Notice of CPU Boards Changes (For Use in the Traversing Inverter of 400V class and TIB)

Thank you for selecting a Mitsubishi hoist and related products. This letter is to notify the CPU boards changes (for use in Traversing Inverter of 400V class and TIB).

Subject	Notice of CPU Boards Changes (For use in the Traversing Inverter of 400V class and TIB)	Date of issue	April 29, 2016	Notified to
		MITSUBISHI ELECTRIC FA INDUSTRIAL PRODUCTS CORPORATION 1-1-1 Imajuku-Higashi, Nishi-ku, Fukuoka 819-0192 TEL 092-805-3631		Sales agent

CPU boards for traversing

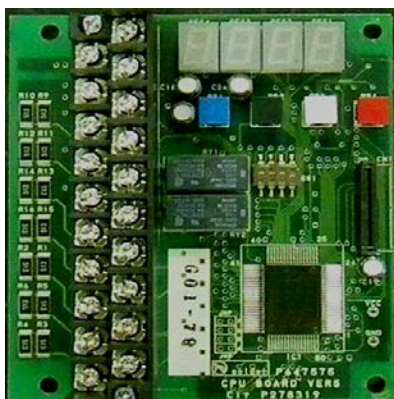
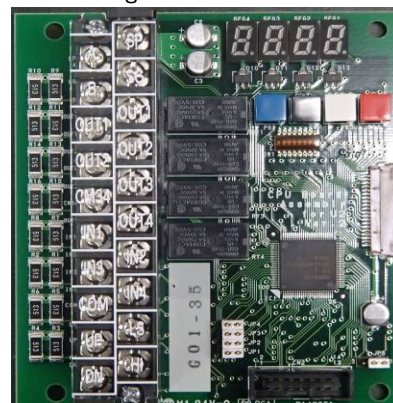
- (1) The function of error detection output and operation status output are equipped as standard.
- (2) **【New function】** The synchronism operation function (when using two hoists at together) is included as safety function.
- (3) It is possible that to set the frequency per 0.1Hz when the frequency is 10Hz and under.
- (4) The improved sinusoidal modulus makes low noise.
- (5) Switching product is compatible with existing product.
- (6) **Ensure that a wire is rewired, and set the function selector switch when replacing a board.**
- (7) Refer to the Instruction Manual about details and setting of additional functions.

CPU board	Existing Product		Switching Product	
	Part Code	Drawing. No	Part Code	Drawing. No
	03G54L	P647575G05	03G572	PA01133G01
